PROJECT NAME: A New Building for: Dalton Police Department  
For The City of Dalton, GA

PROJECT NUMBER: 23-021

FROM: KRH Architects  
855 Abutment Road  
Suite 4  
Dalton, GA 30721

**Item No. 1****Prebid Sign In Sheet**

**A1.8**

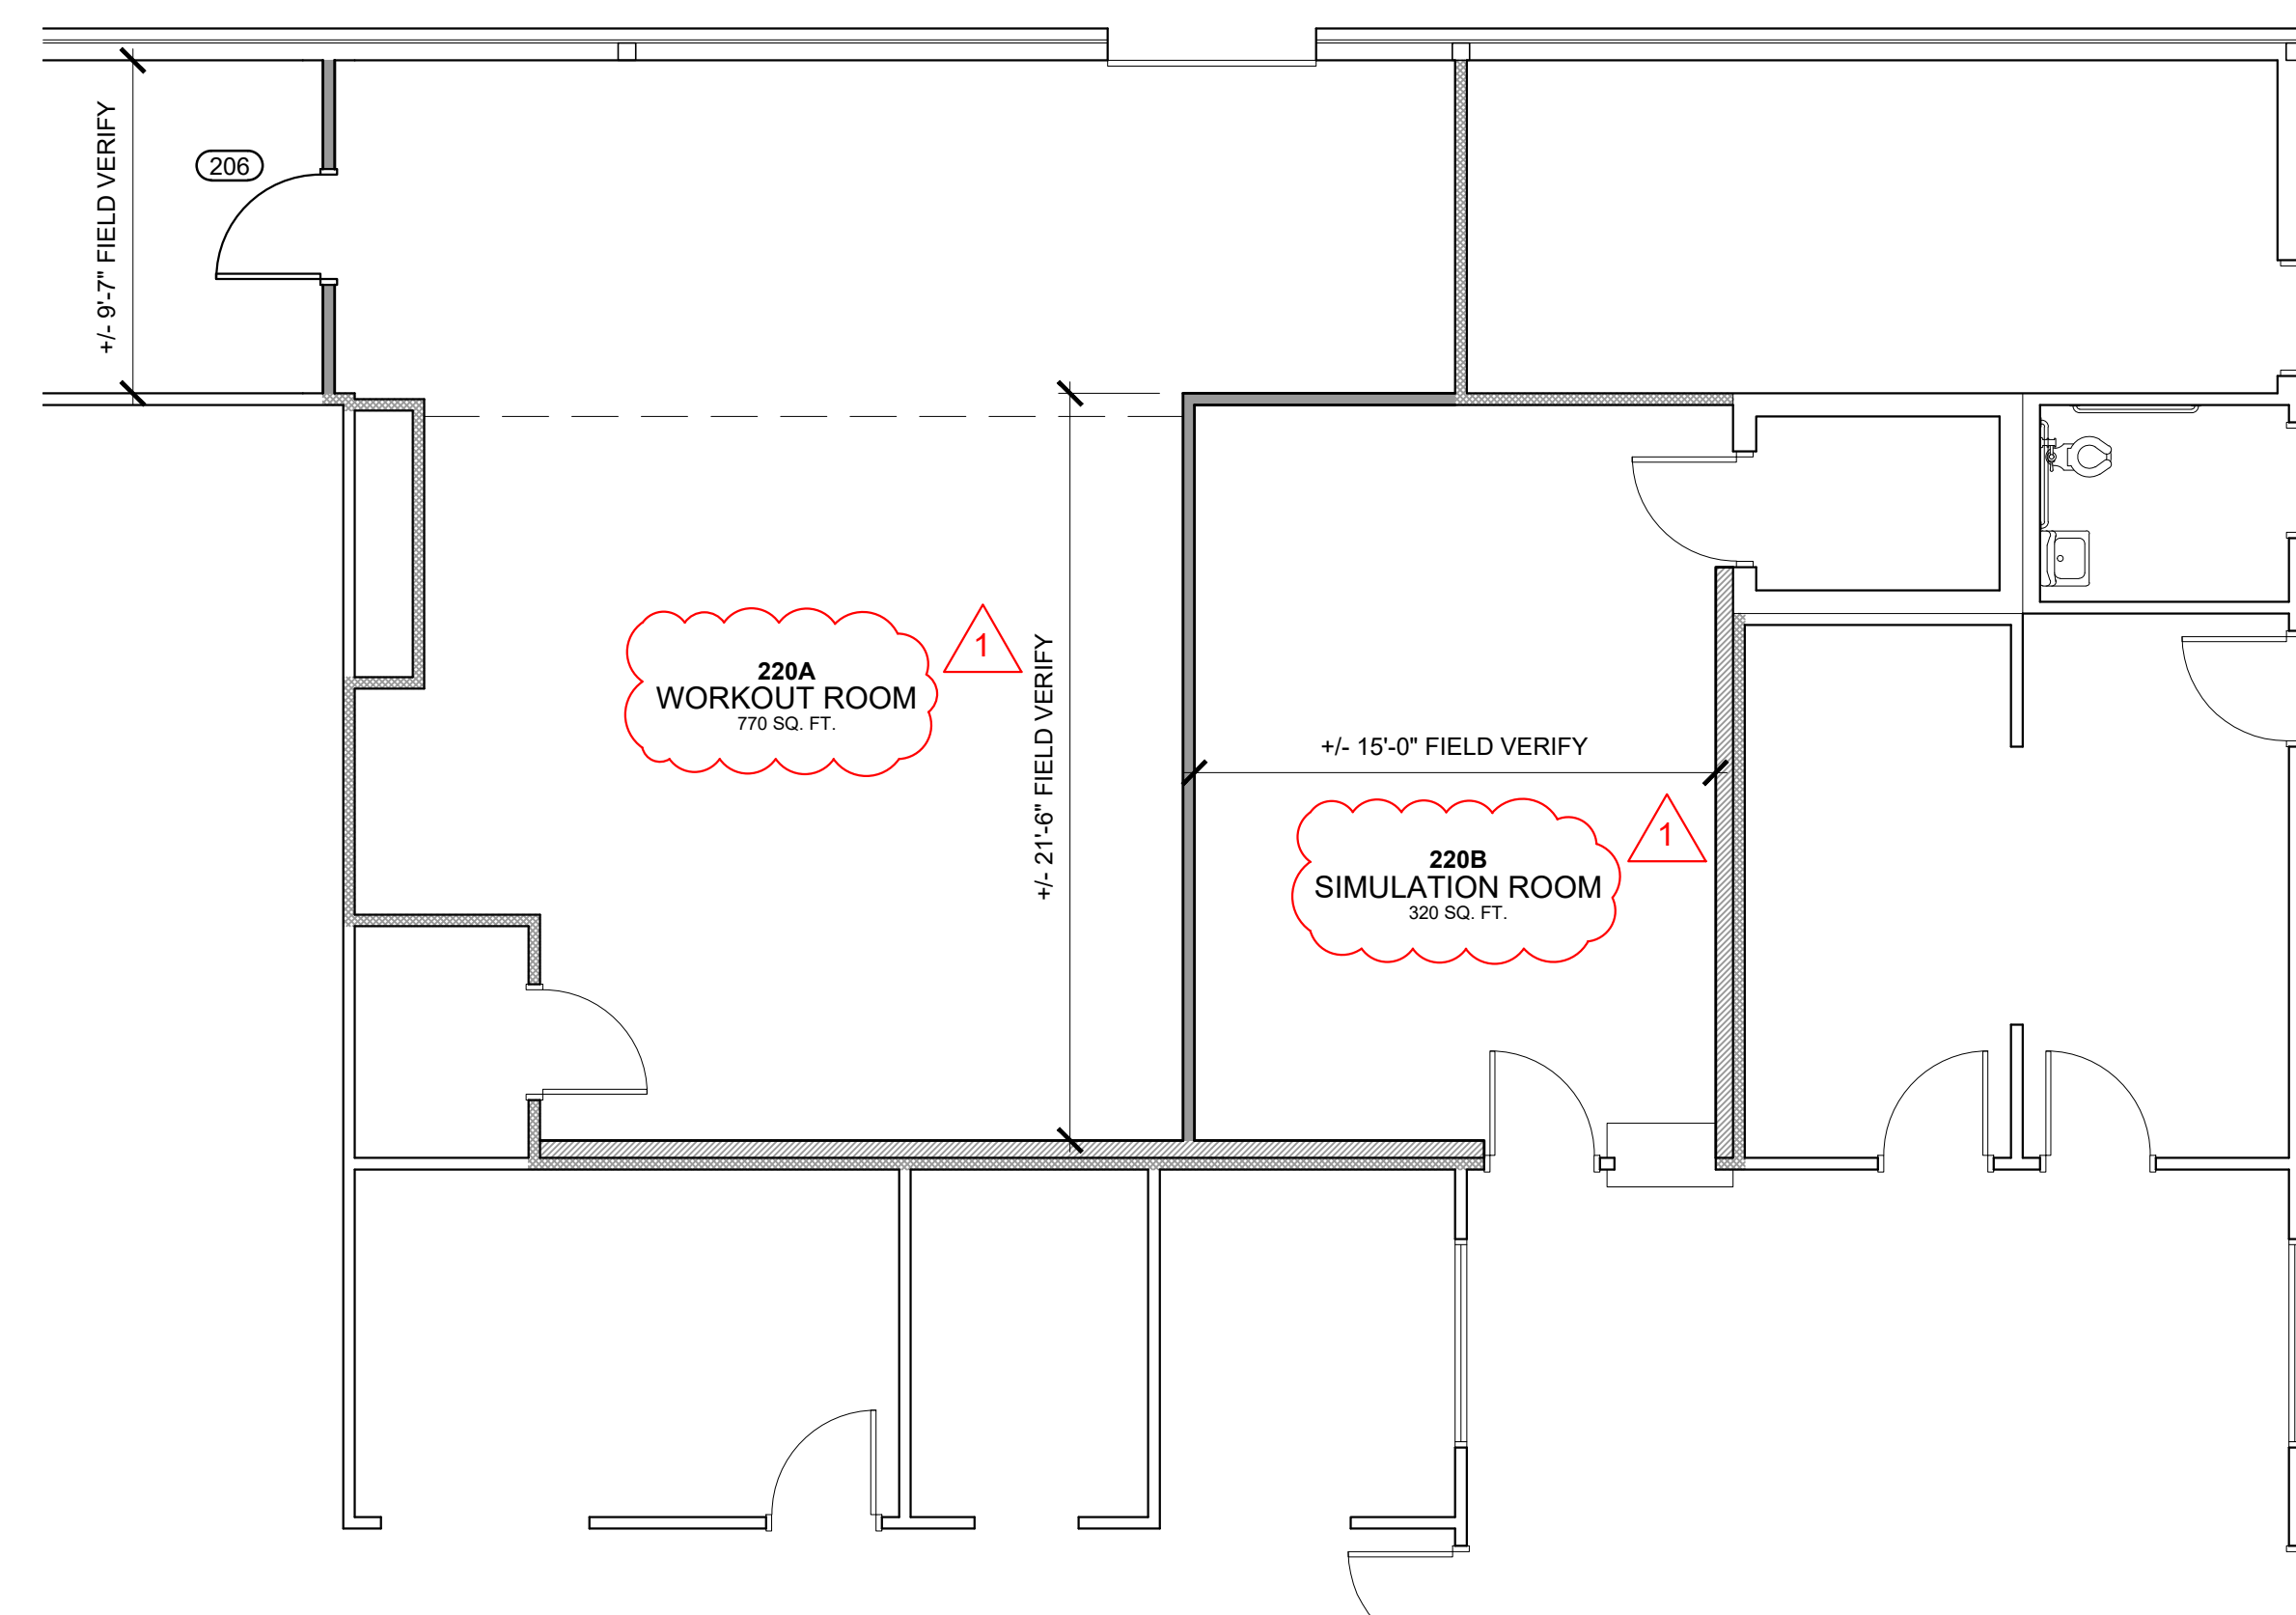
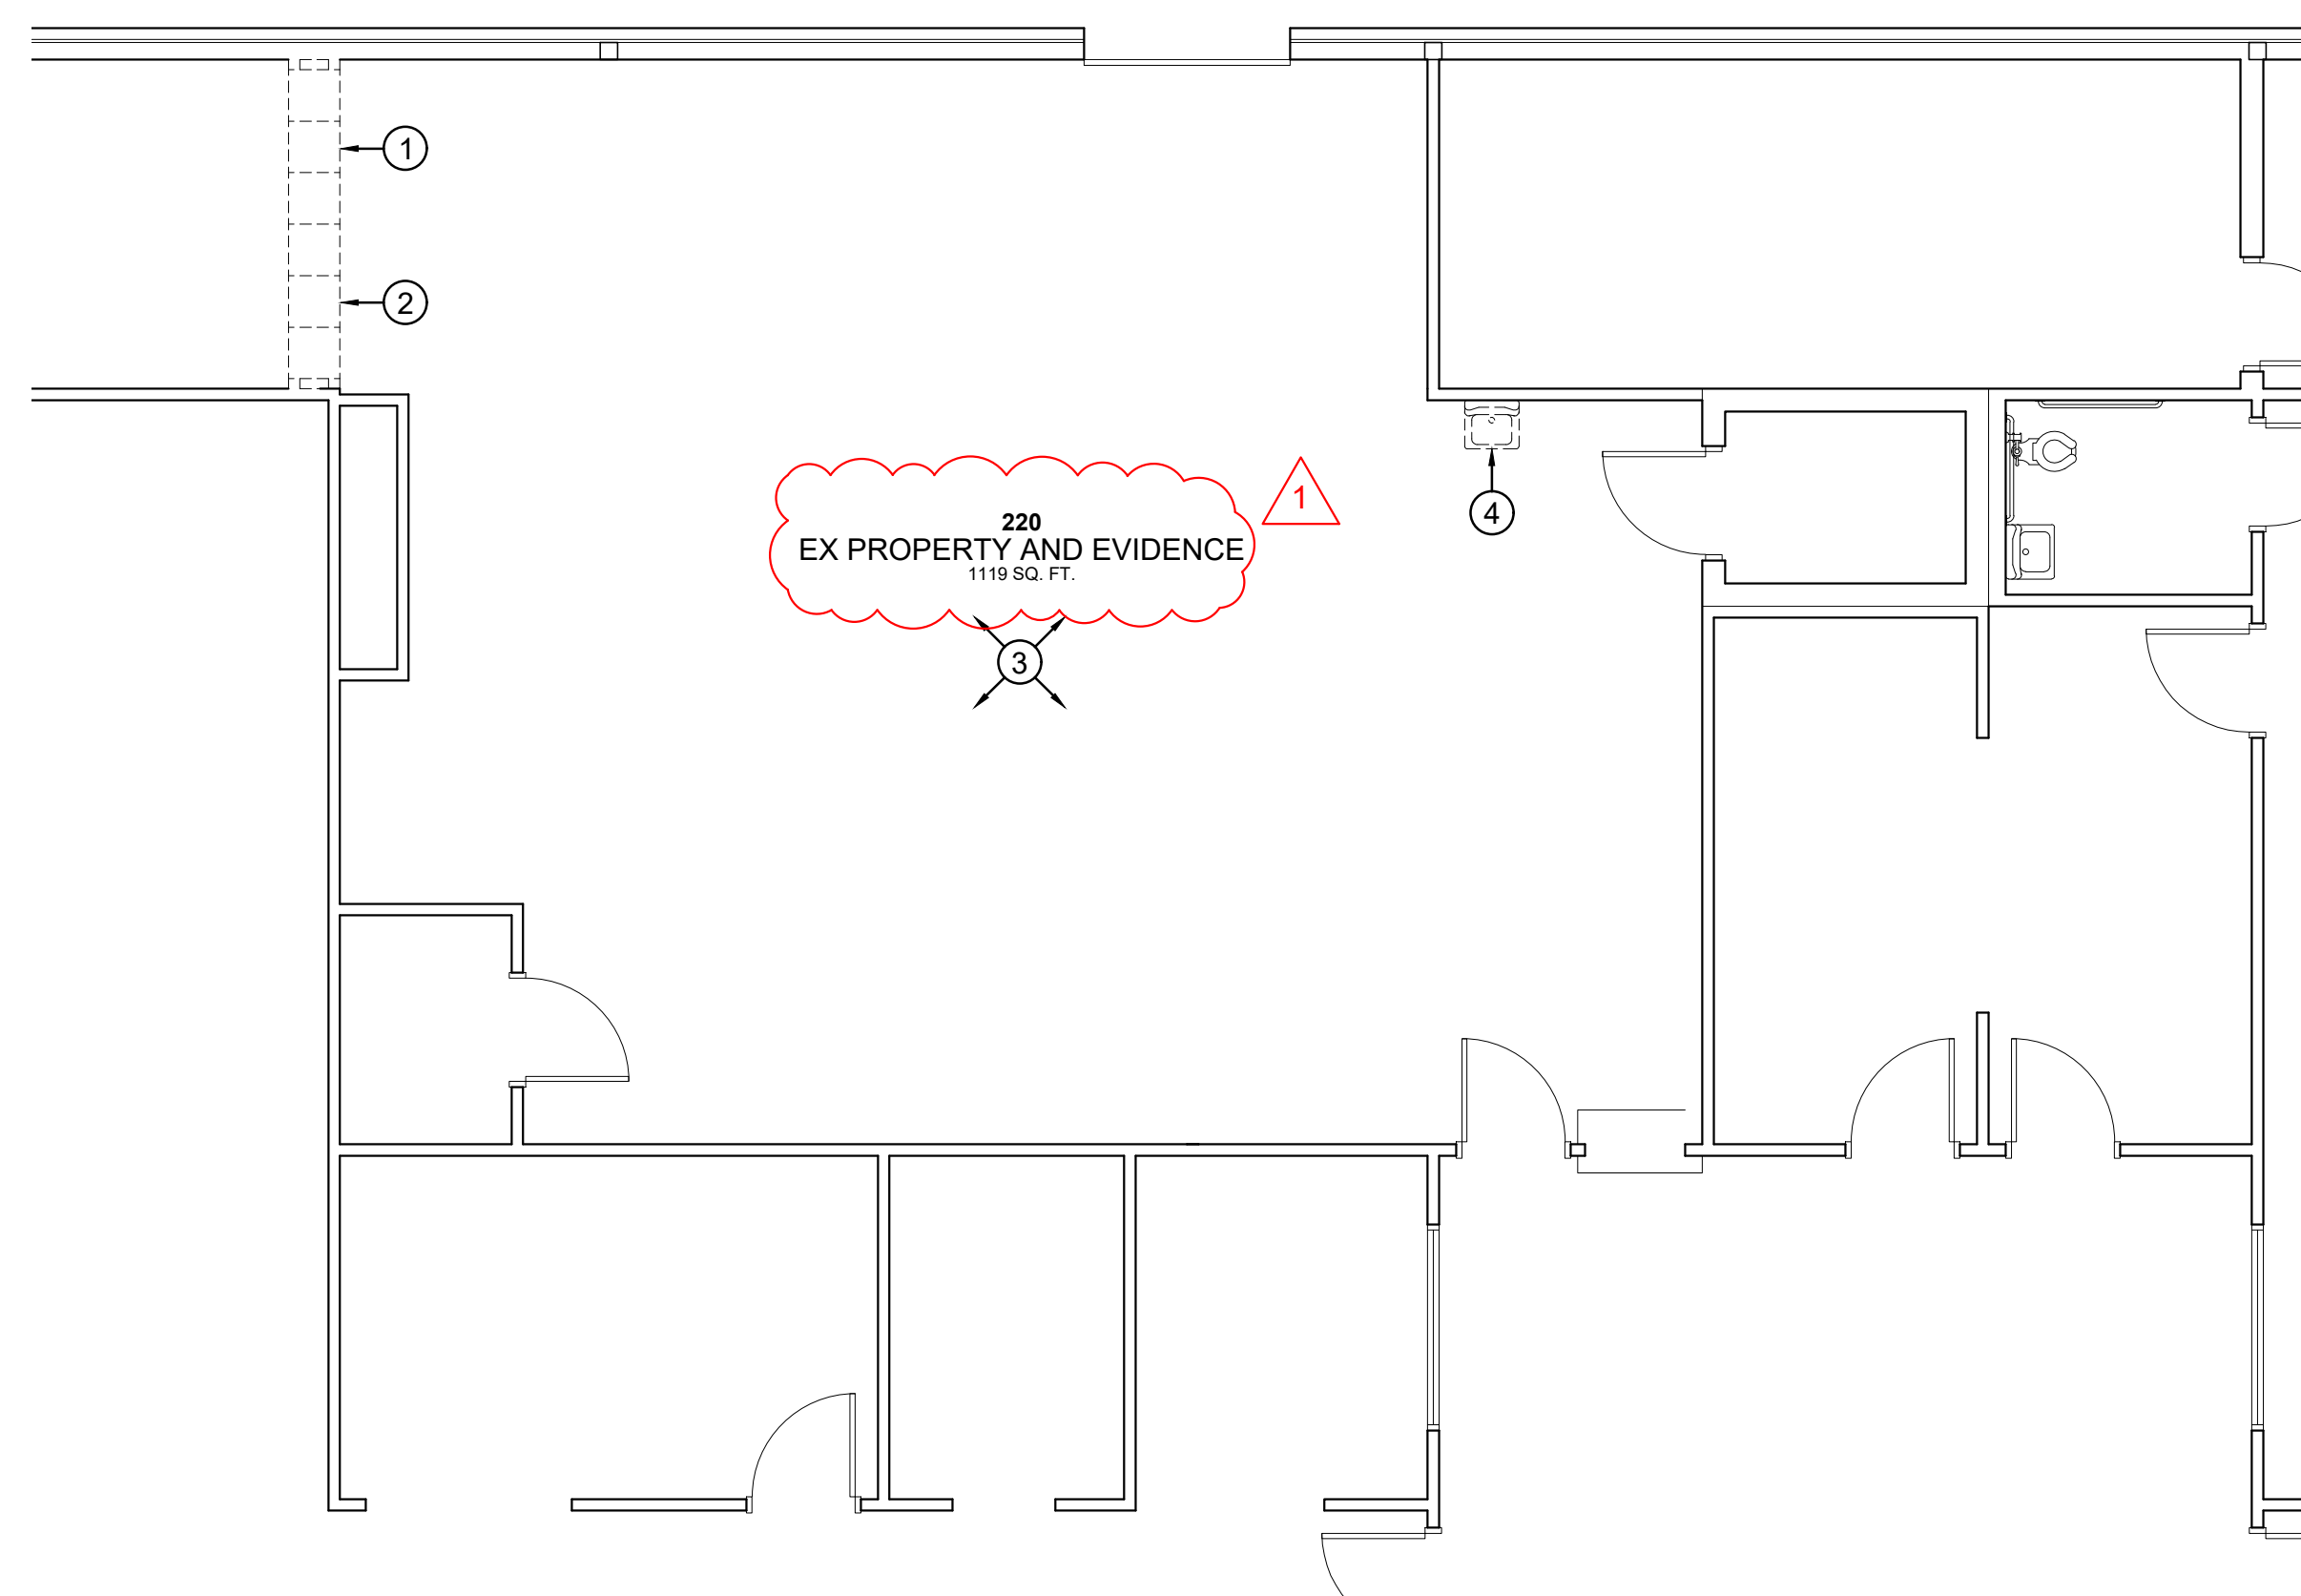
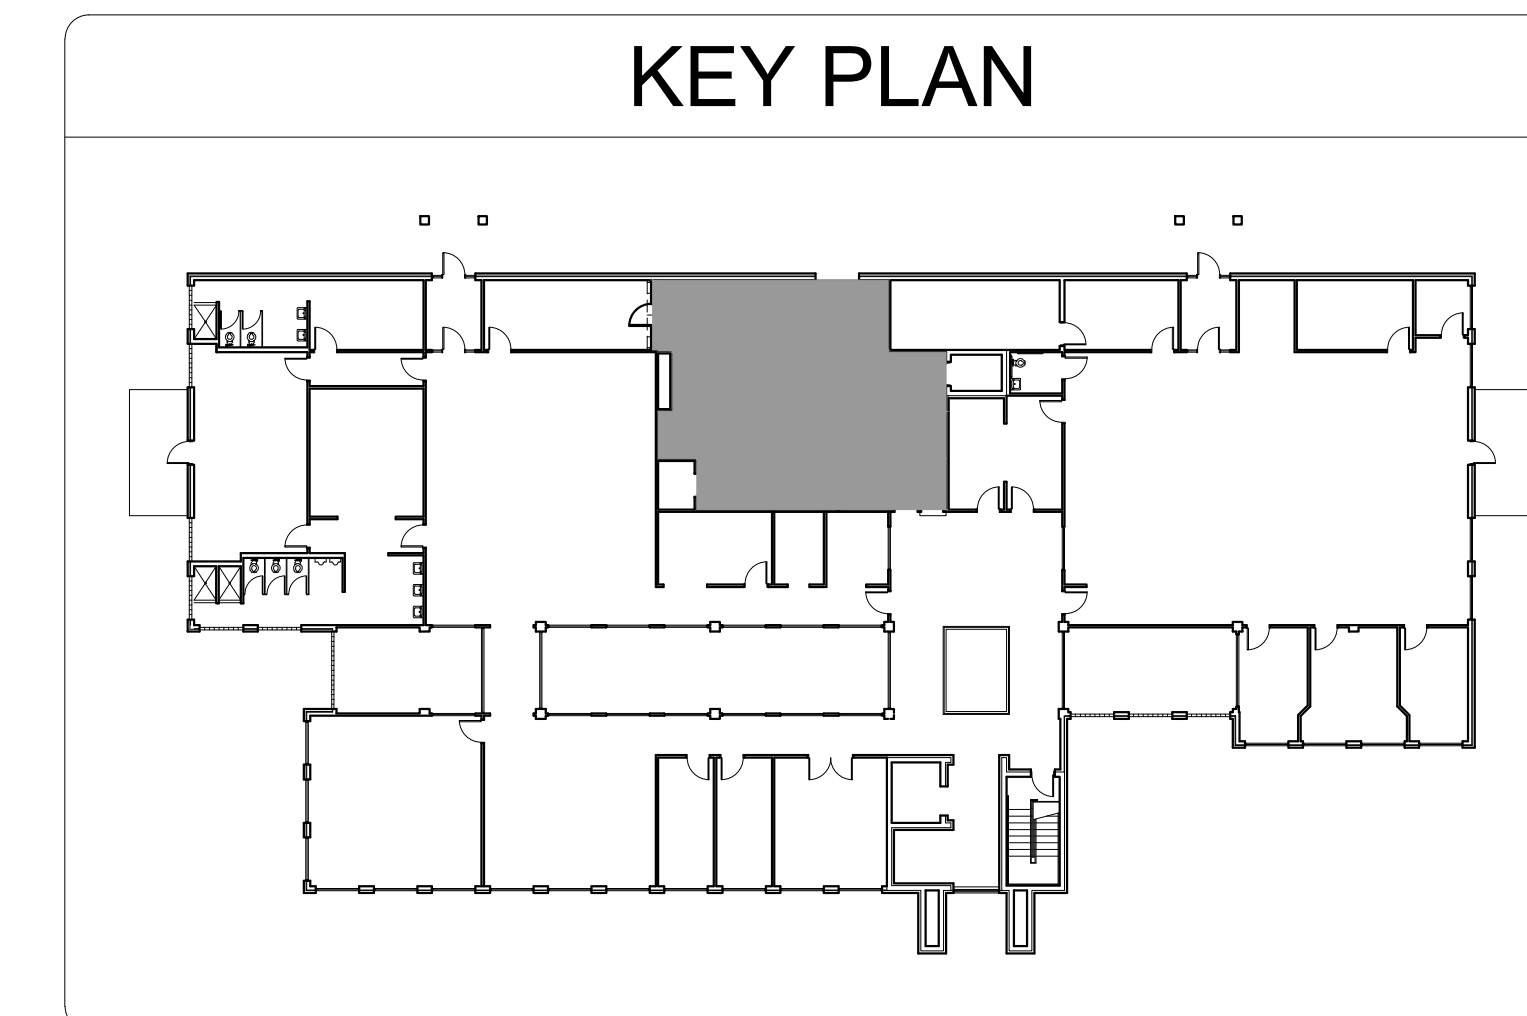
2. Is there going to be a Drawing that comes out for the labels on the Demolition in the Existing. On page A1.8. **Answer: Yes. Please see sheet A1.8 in addendum No.1. Room labels have been added.**

3. The finish schedule on drawing A8.1 shows Workout Room 220A is to receive resilient athletic flooring and rubber base and the Simulation Room 220B is to receive LVT and rubber base. I have not been able to locate these rooms on the Second Floor Plan. Please advise. **Answer: These spaces are in the existing building. Please see sheet A1.8 in addendum No.1. Room labels have been added.**
